Addendum #1

Project: City of Bangor
690 Maine Avenue Roof Renovations

Job: 16048

Date: 03/29/2016

TYP. ROOF SECTION
NOT TO SCALE

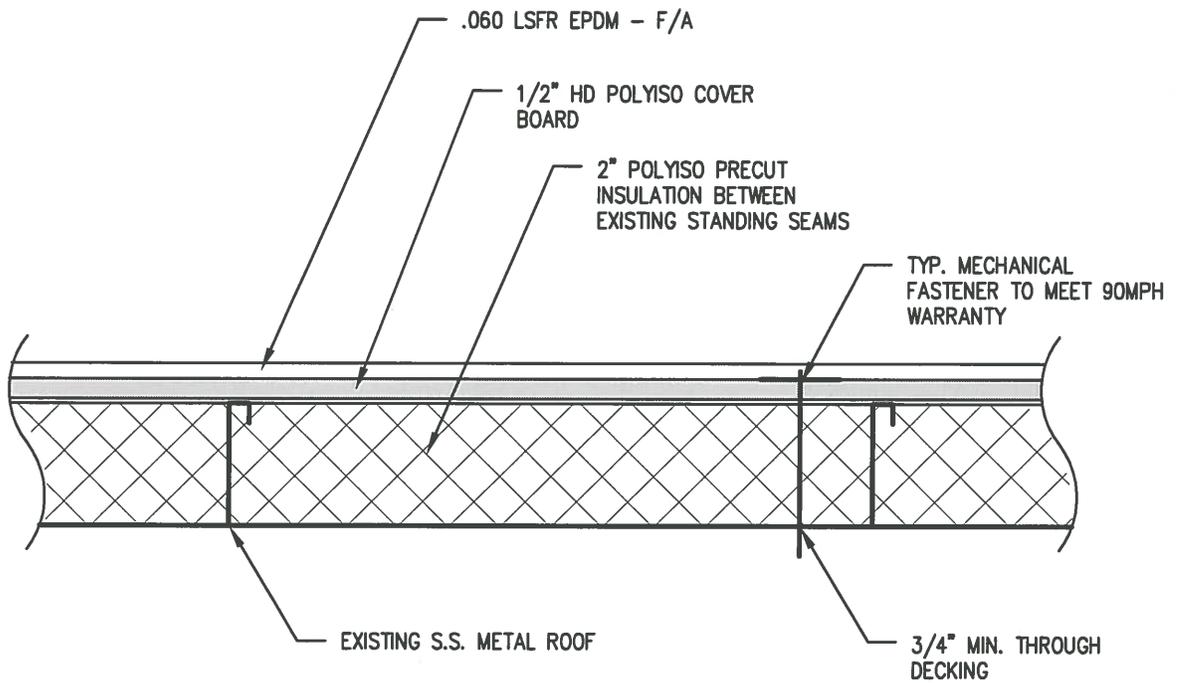
1. The existing standing seam metal roof shall have 2" pre-cut flute filler POLY-ISO. The 1/2" HD-ISO GARD cover board will be installed over both flute filler and the ribs of existing S.S. Roof. The cover board shall be mechanically fastened through the flute filler into the existing metal roof. The fasteners must penetrate the existing S.S. Roof a minimum of 3/4". The mechanical fasteners must be installed according to manufacturer's guidelines. The EPDM membrane is attached, utilizing a low-voc bonding adhesive and must be installed per manufacturer's specifications. The project will require a 20-yr., 90 mph manufacturer's warranty upon completion.
2. Use LSFR membrane and fire-rated assemblies.
3. FM refers to require factory mutual approved components and assemblies.
